3. Media access control frame structure

Draft 0.1, March 2005 Initial draft for FE Task Force review.

Figure 3-2—MAC frame format

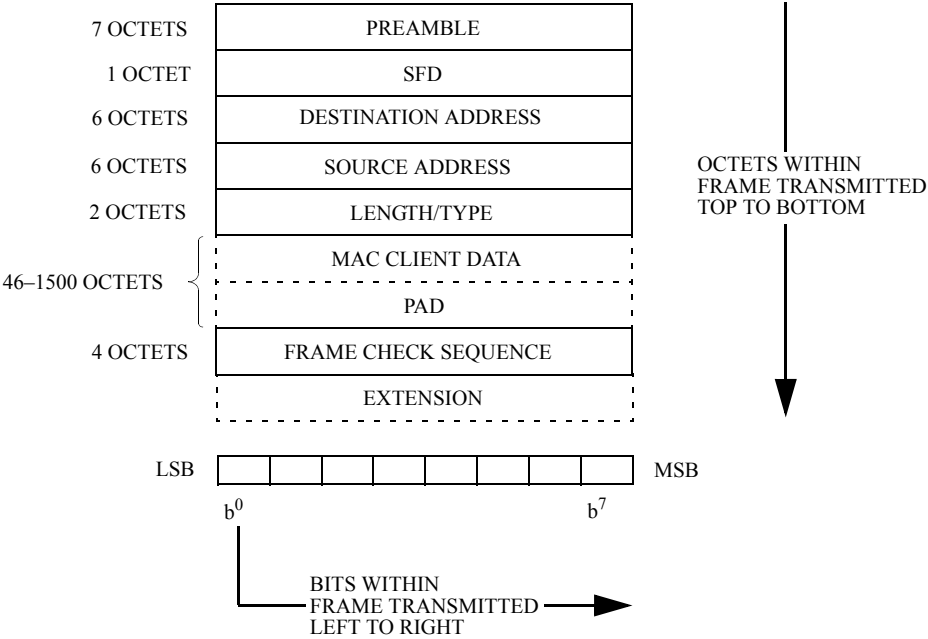
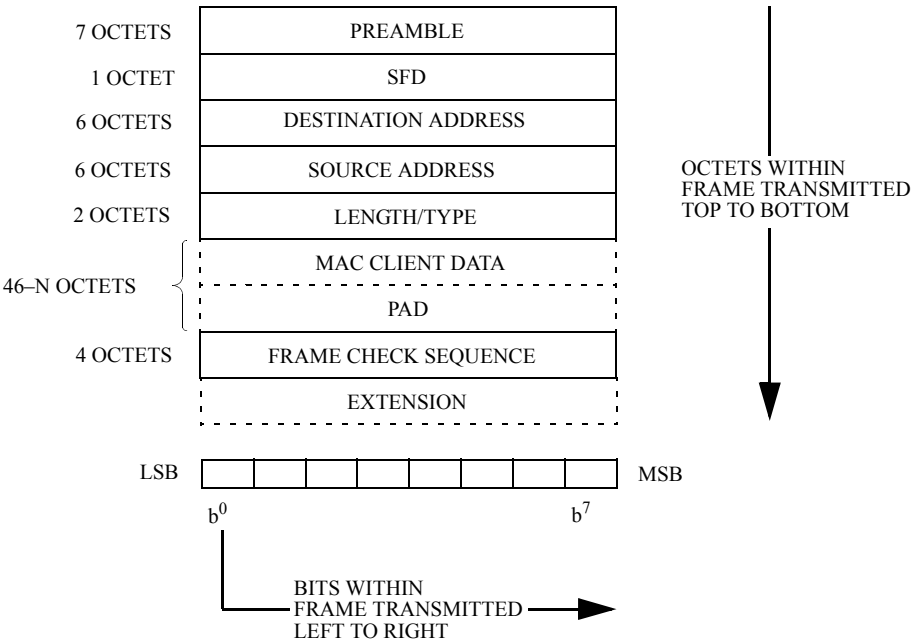
Figure 3–2 shows the nine fields of a frame: the preamble, Start Frame Delimiter (SFD), the addresses of the frame's source and destination, a length or type field to indicate the length or protocol type of the following field that contains the MAC ~~Client~~-client data, a field that contains padding if required, the frame check sequence field containing a cyclic redundancy check value to detect errors in a received frame, and an extension field if required (for 1000 Mb/s half duplex operation only). Of these nine fields, all are of fixed size except for the data, pad, and extension fields, which may contain an integer number of octets between

The maximum size of the data field is determined by the application of the particular implementation. The value of N in Figure 3–2 is enumerated for three applications as follows:

- a) N=1500 decimal - basic frames that are either length or type encoded with no additional tags (i.e., untagged)
- b) N=1504 decimal - frames that contain a IEEE 802.1Q tag (i.e., QTagged)
- c) N=1982 decimal - envelope frames

Figure 3-5—Tagged MAC frame format

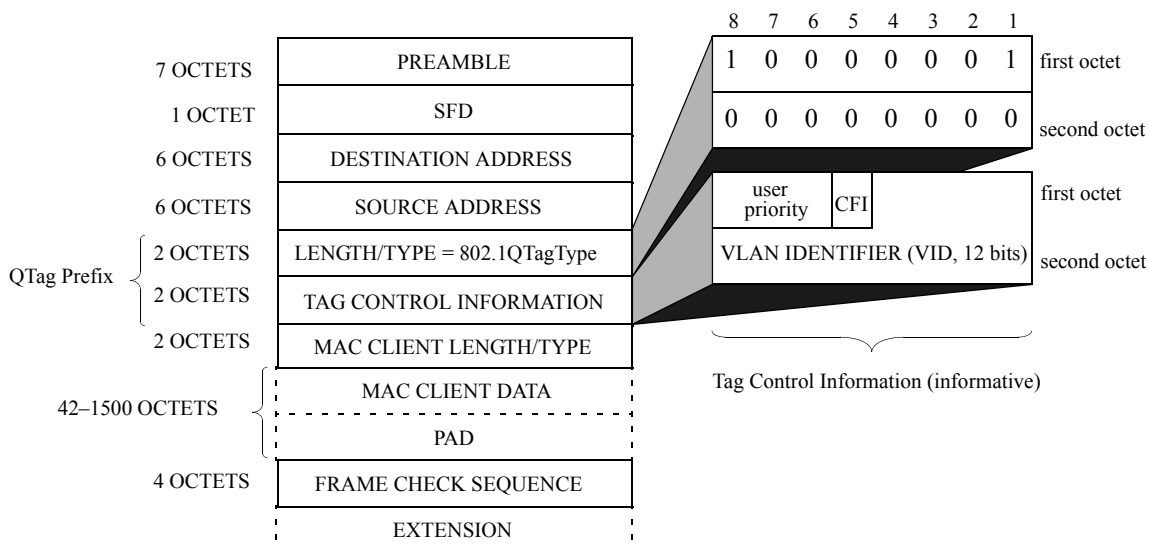
~~NOTE—The normative definition of the Tag Control Information field shown in Figure 3-5 can be found in IEEE P802.1Q. Also, while Figure 3-2 uses the convention that the most significant bit of an octet is the rightmost bit, Figure 3-5 uses the opposite convention, i.e., the most significant bit is shown in the leftmost position. The latter convention is consistent with the specification of IEEE P802.1Q. This is a pictorial difference only; there is no difference in the actual order of bits transmitted on the LAN.~~
